PROJECT NO. U-0620
CUMBERLAND COUNTY
 STATION: 161+95.29 -L-
 SHEET 1 OF 5
 BRIDGE No. 348
 MILEPOST A-215.60

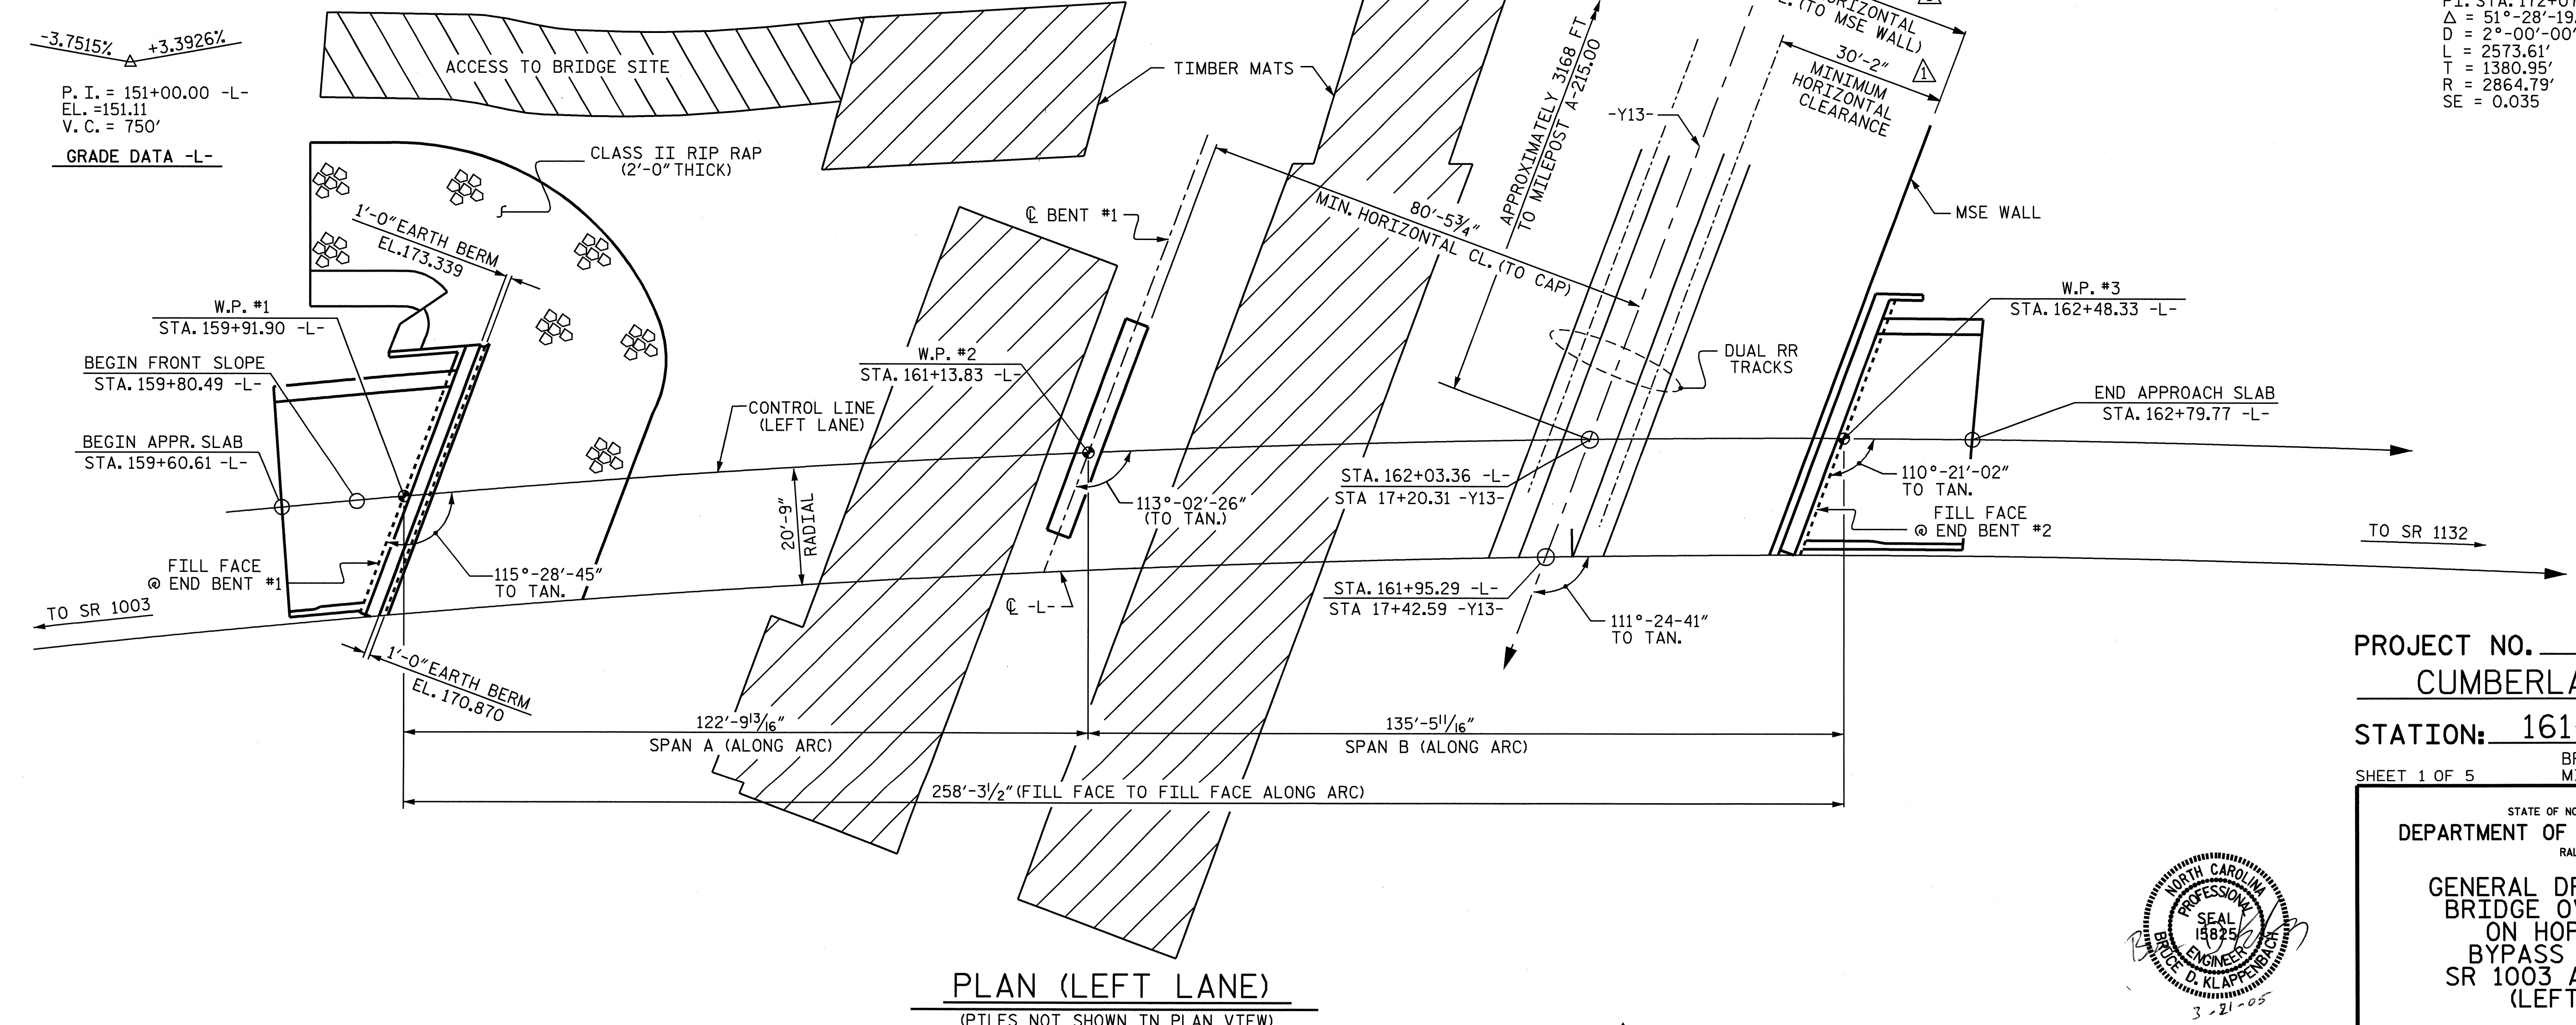
REVISION : REVISED MINIMUM HORIZONTAL CLEARANCE.
 CHANGE BRACE PILES TO VERTICAL PILES AT END BENT #2.
 BY : JBW CHECKED BY : BDK
